Re: Semi-Annual Report Uranerz Energy Corporation Nichols Ranch ISR Project SUA-1597

Semi-Annual Report

July - December 2014

INDEX SHEET FOR MINE PERMIT AMENDMENTS OR REVISIONS

FIGURE 5-1 URANERZ ORGANIZATION

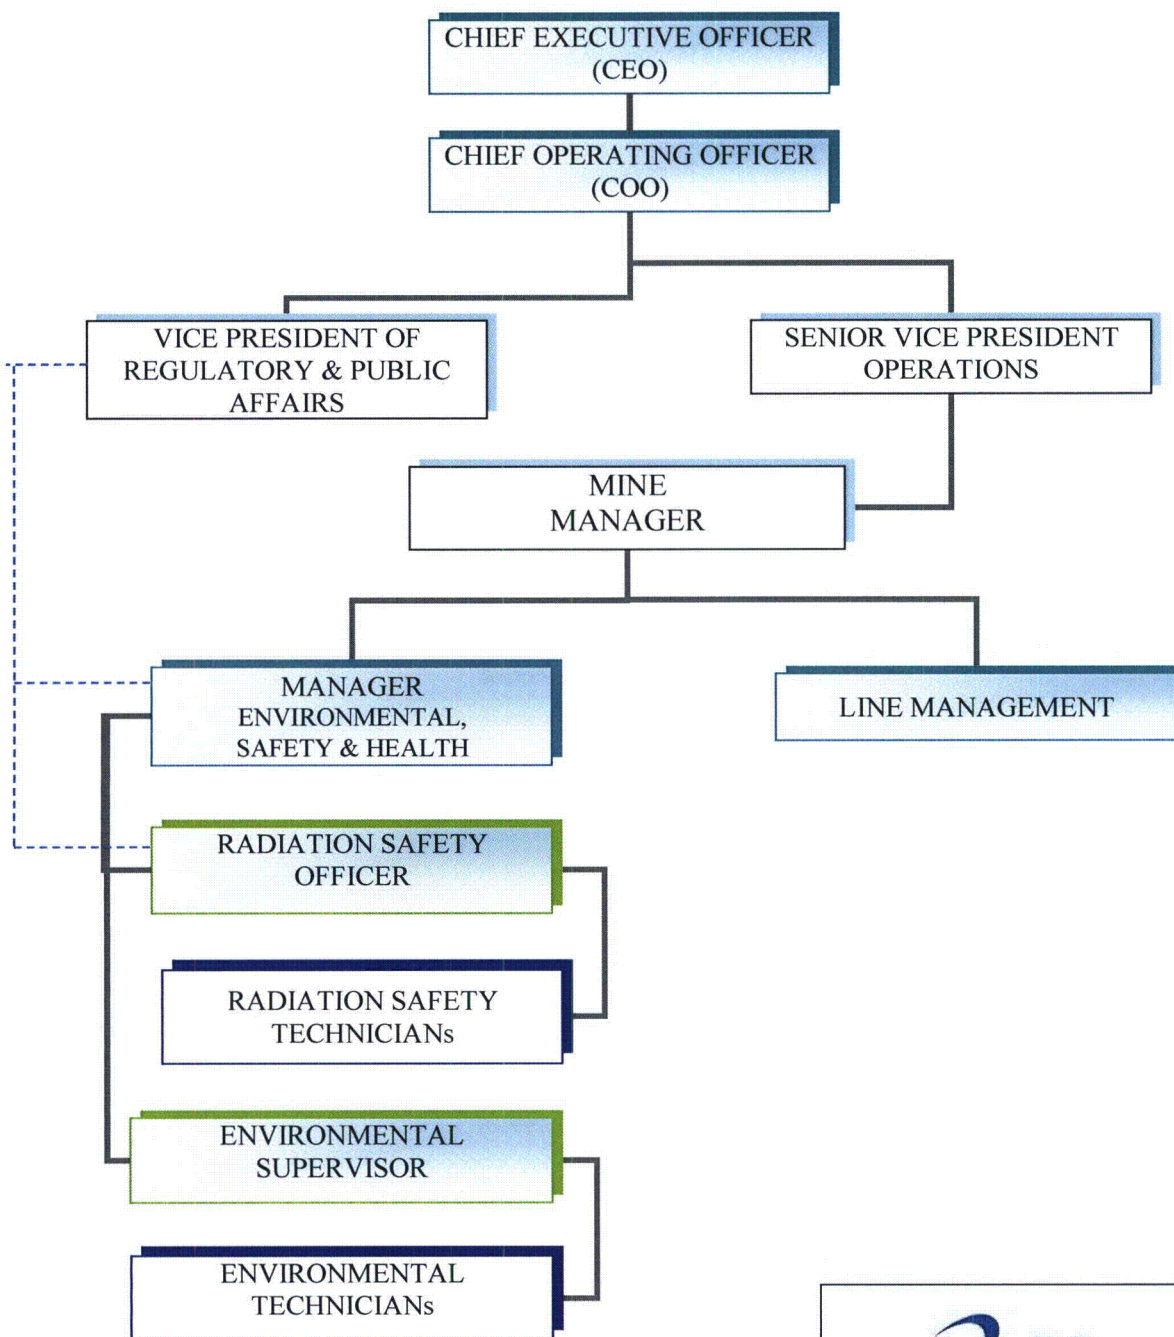
SERP No.	Date	SERP Topic	Evaluation Summary
SERP-6-2014	12/16/2014	Management - Organizational Structure Change	<p>The SERP evaluated changes to Chapter 5 of the Mine Plan regarding Management. Two changes were evaluated. The first was the edition of the position of the Chief Operating Officer (COO) and the next was a title change pertaining to the Vice President Regulatory Affairs. The title change simply was revised to Vice President Regulatory and Public Affairs. The COO is a similar position to the Executive Vice President position initially provided in the license application. The COO responsibilities and authorities were included. Text narrative and Figure 5-1 were revised to reflect the changes. The SERP concluded that the changes will not result in increased safety or radiological hazards and will ultimately result in additional management resources similar to that already described in the SER.</p>

Volume Number	Page, Map or other Permit Entry to be REMOVED	Page, Map or other Permit Entry to be ADDED	Description of Change
Volume I	Mine Plan Section 5.1.1, Pages TR-202 through TR-204 (Revised October 2013), Page TR-205 (Revised June 2012) , Page TR-206 (Revised October 2013 and Figure 5-1 (October 29, 2007)	Mine Plan Section 5.1.1, Pgs. TR-201 through TR-204 and Figure 5-1 (Revised December 22 2014)	Pages revised for Section 5.1.1 Management, Figure 5-1 revised to reflect narrative changes
Volume I	Mine Plan Section 2.0 , Figure 2-25 (Date: 12/02/2008)	Mine Plan Section 2.0, Figure 2-25 (01/30/2014)	Figure 2-25 has been updated and requires replacement.

NICHOLS RANCH ISR PROJECT FIGURE 2-25 NICHOLS RANCH UNIT RADON/GAMMA/AIR PARTICULATE MONITORING LOCATIONS

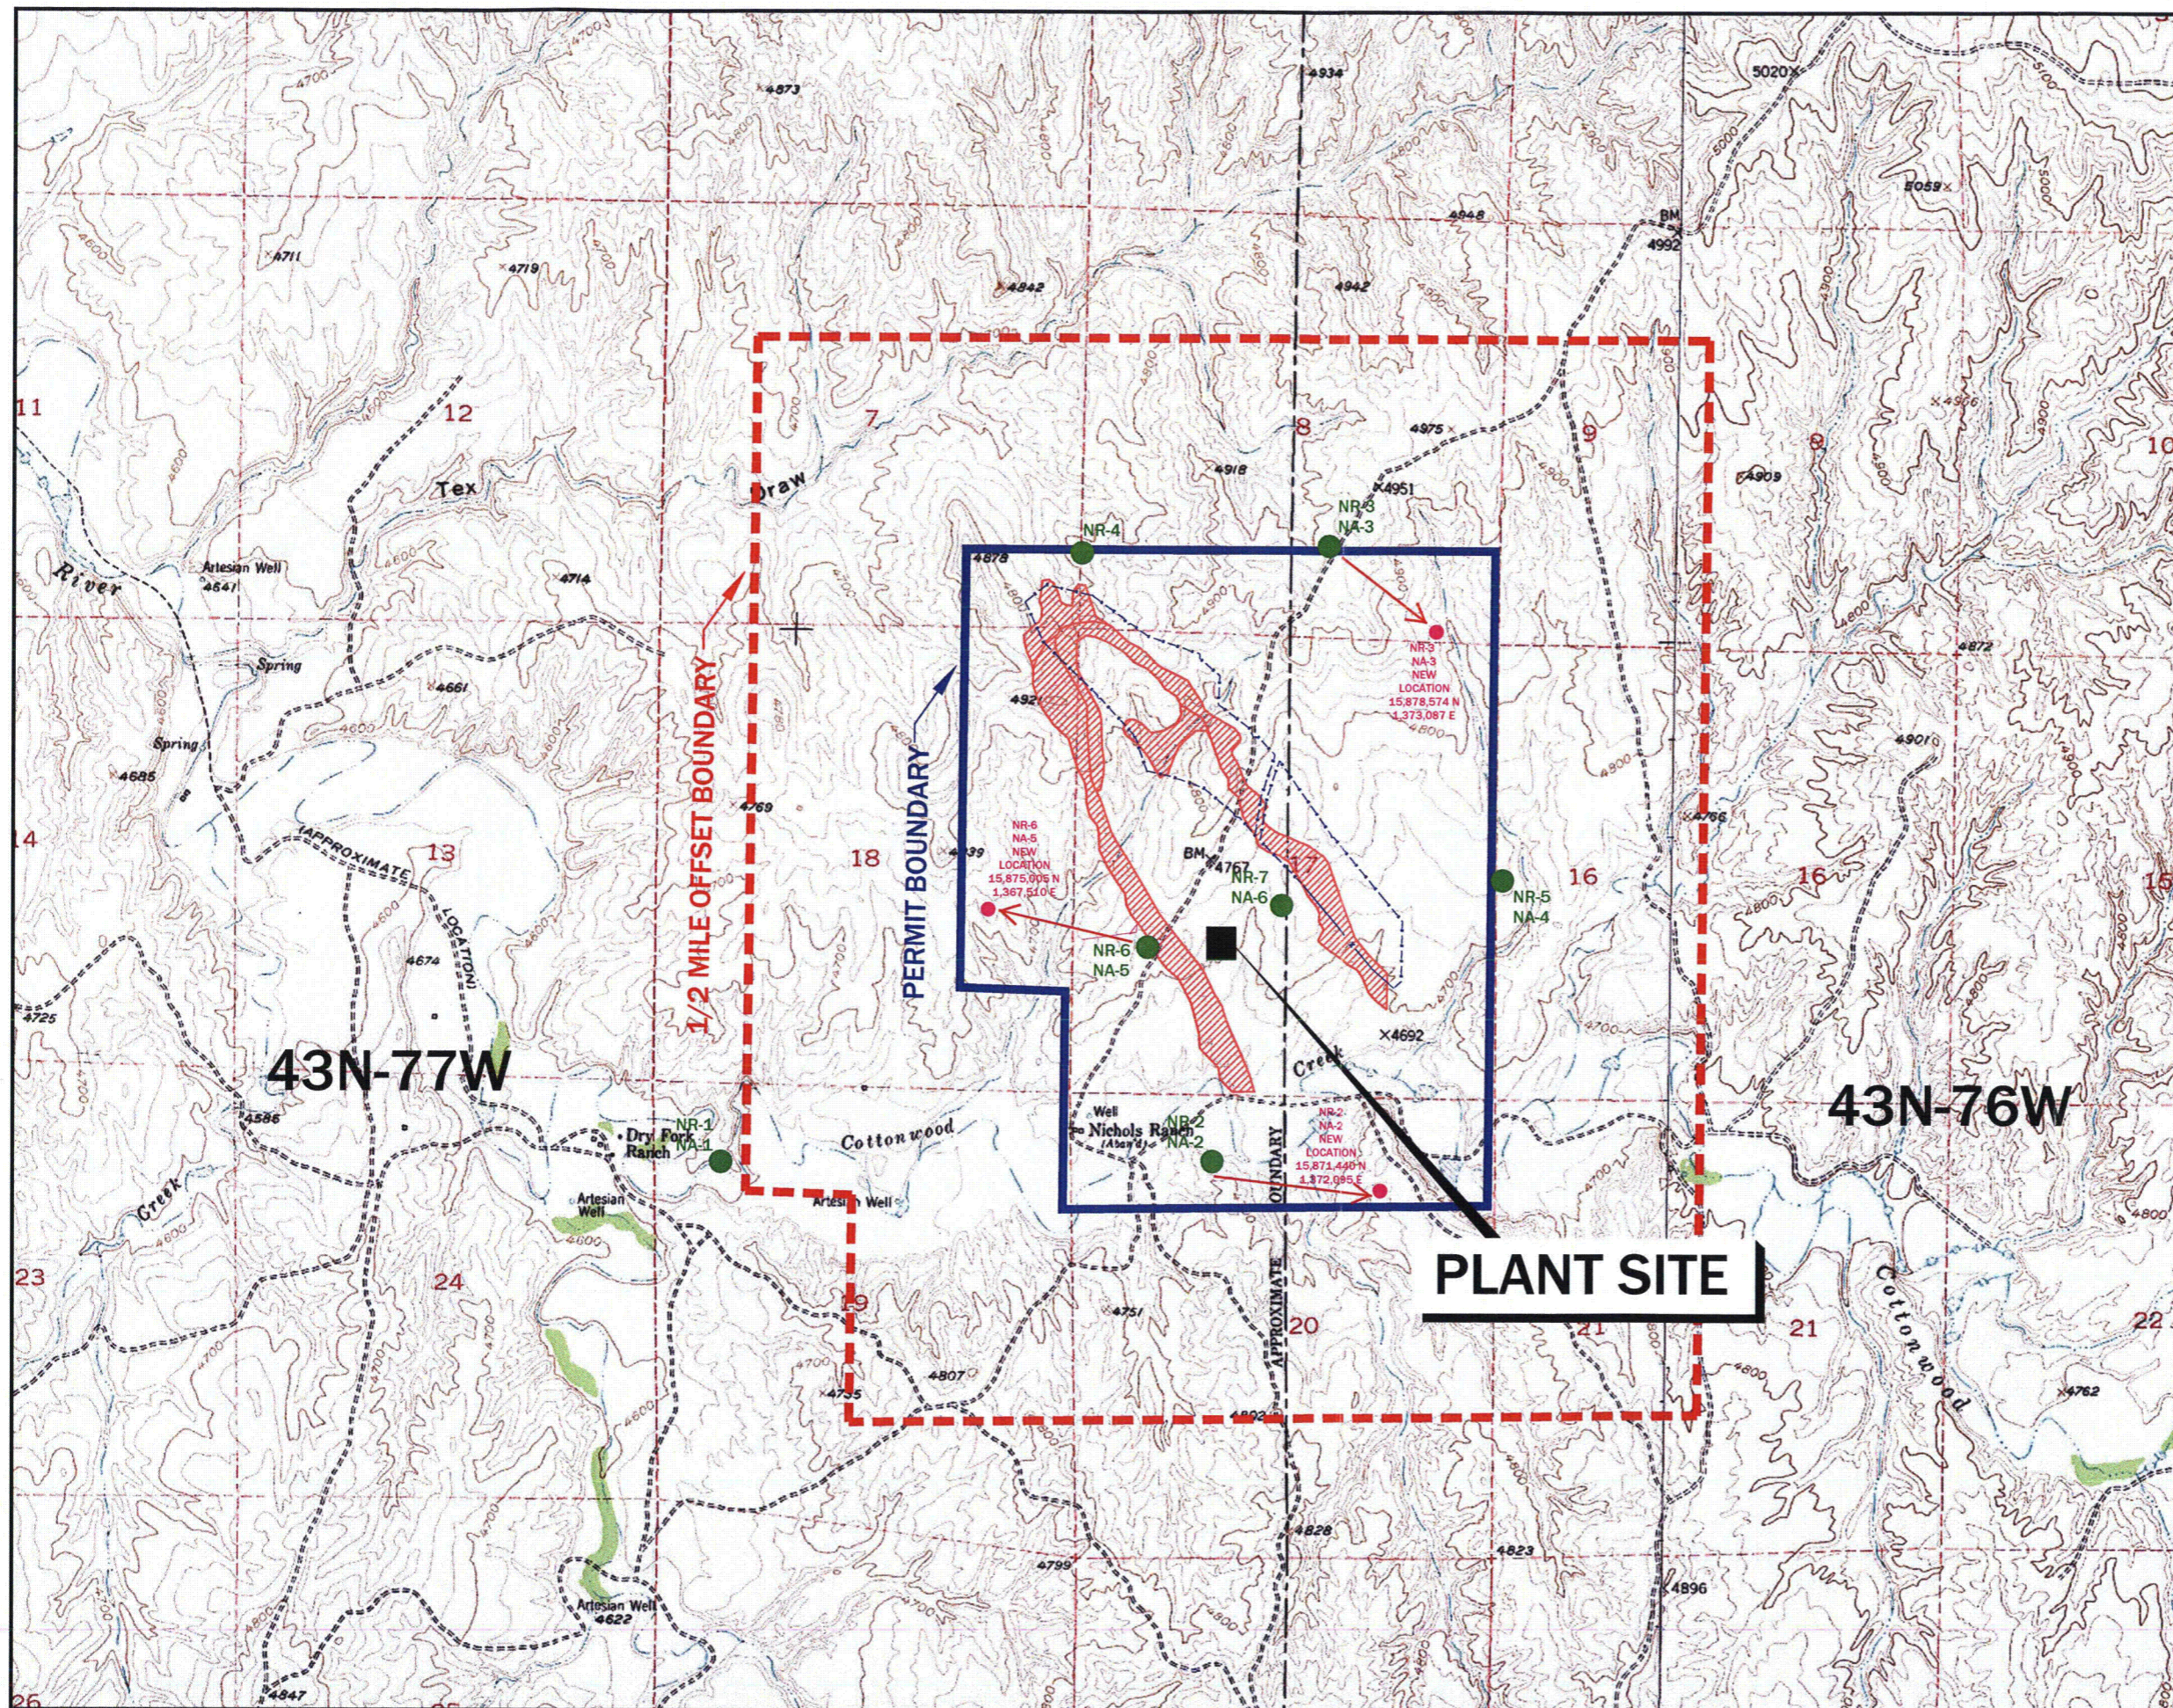
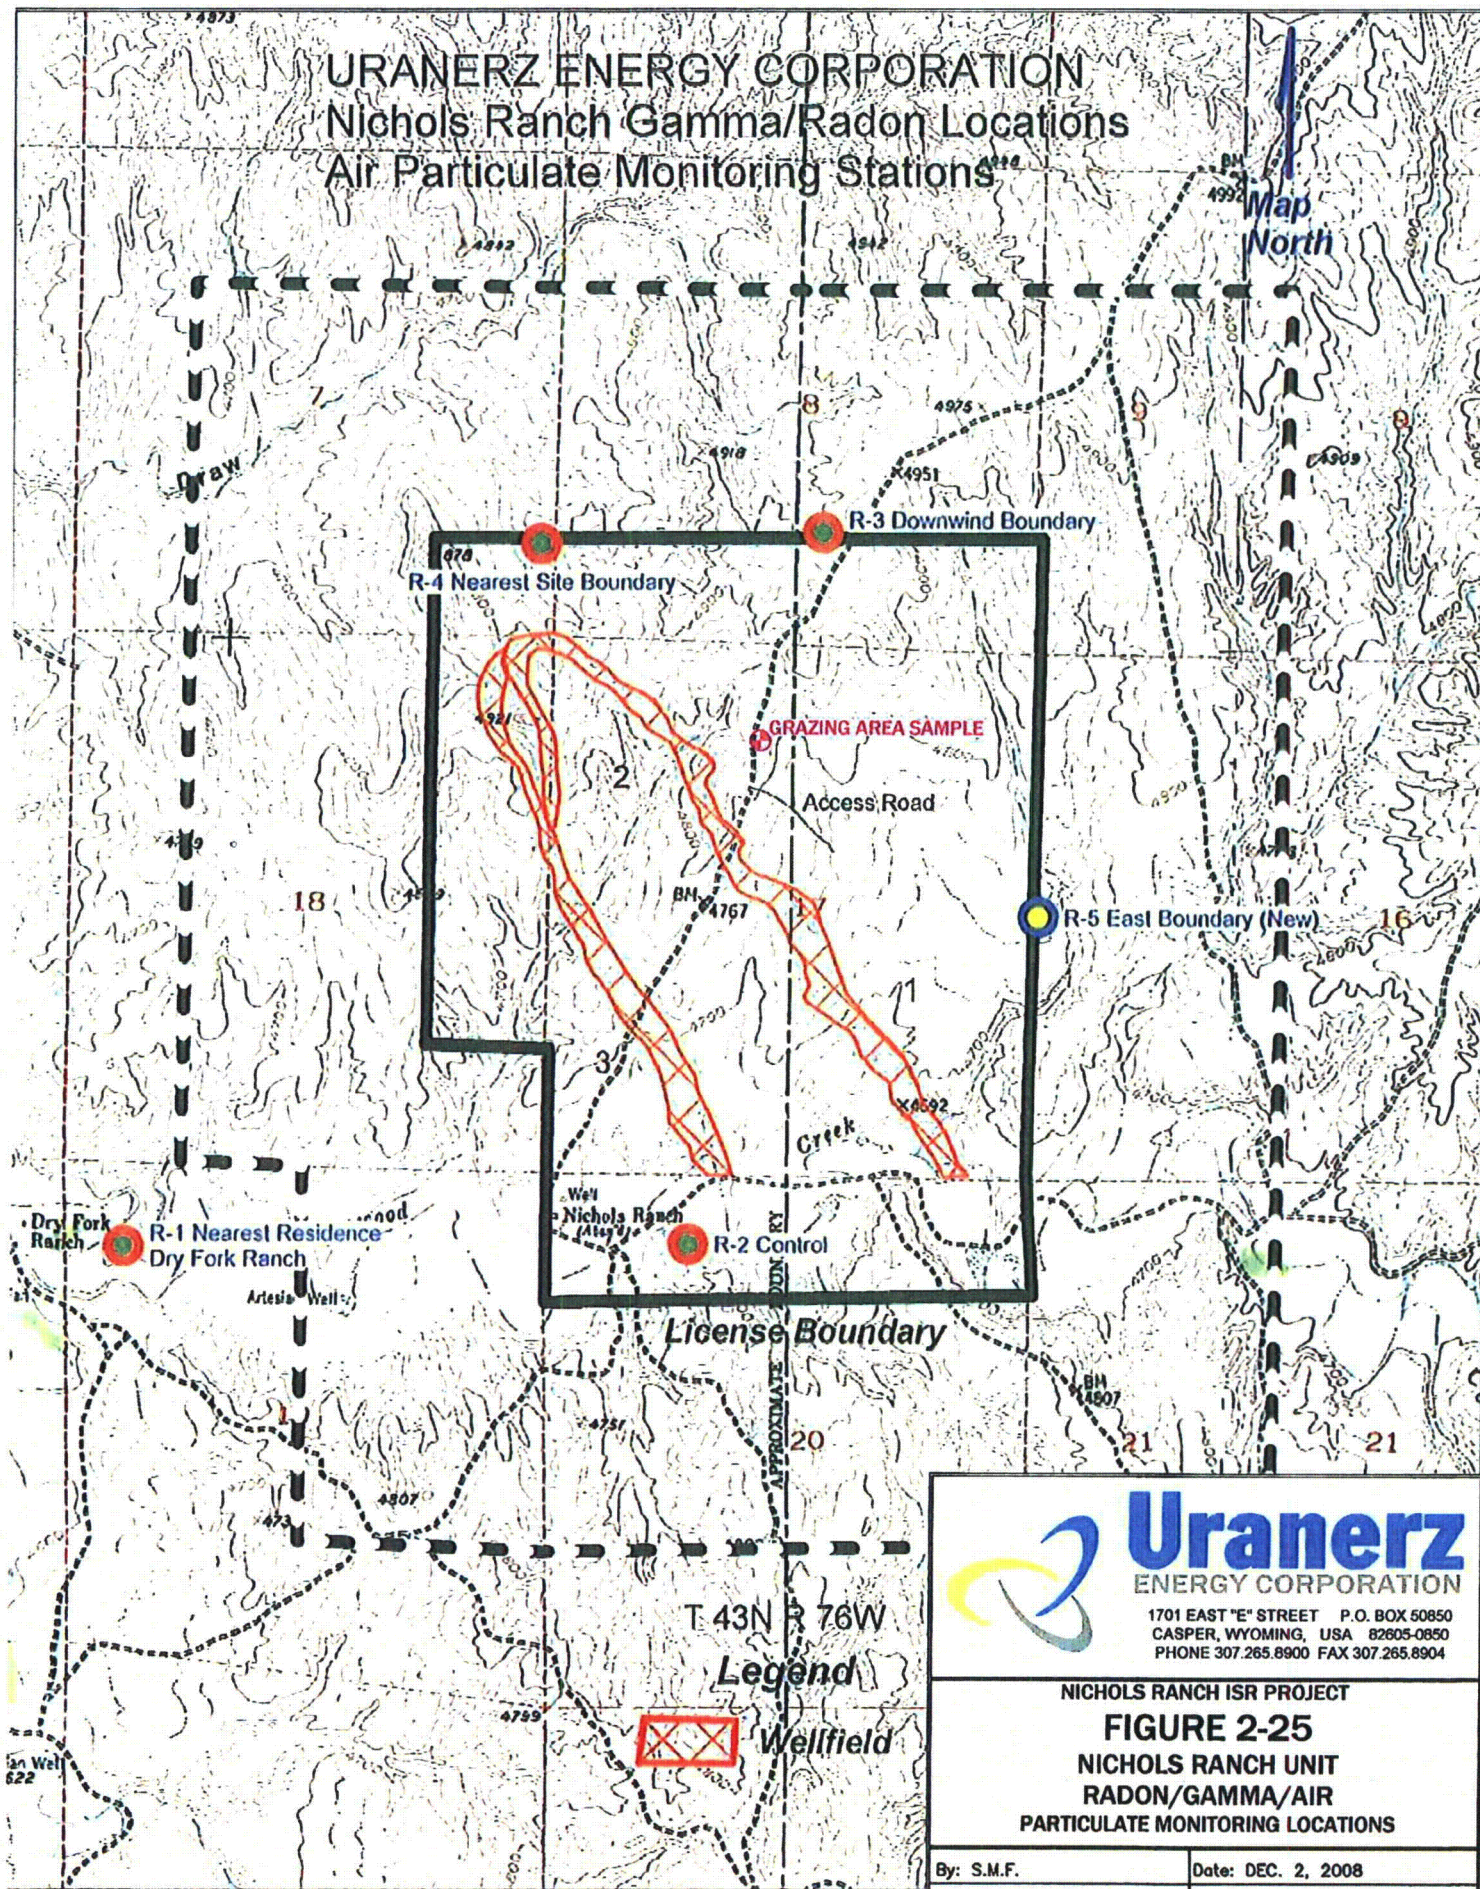
SERP No.	Date	SERP Topic	Evaluation Summary
SERP-1-2014	2/3/2014	Relocation of Air Sampling Monitor Locations	Per license condition 11.9, the licensee shall establish air particulate sampling stations consistent with Regulatory Guide 4.14. The license condition was imposed through the NRC SER which evaluated that the applicant had not demonstrated that the proposed radon monitoring ,air particulate sampling and gamma sampling locations are at locations or in sectors representing the highest predicted airborne concentrations for release from the facility. Specifically the NRC indicated that the applicant did not demonstrate sample conditions are at the predicted highest down wind concentrations for radioactive effluents. Additionally license condition 12.7 required additional meteorological data be collected to obtain data to determinelong term conditions at the site. The SERP evaluated the existing air monitoring station locations and concluded that the meteorological data collected showed a need to relocate three air monitoring stations. The SERP concluded and approved new locations which were only slightly removed from the original locations. Figure 2-25 of the Mine Plan was revised. A copy of this SERP was submitted to the NRC on February 3, 2014.
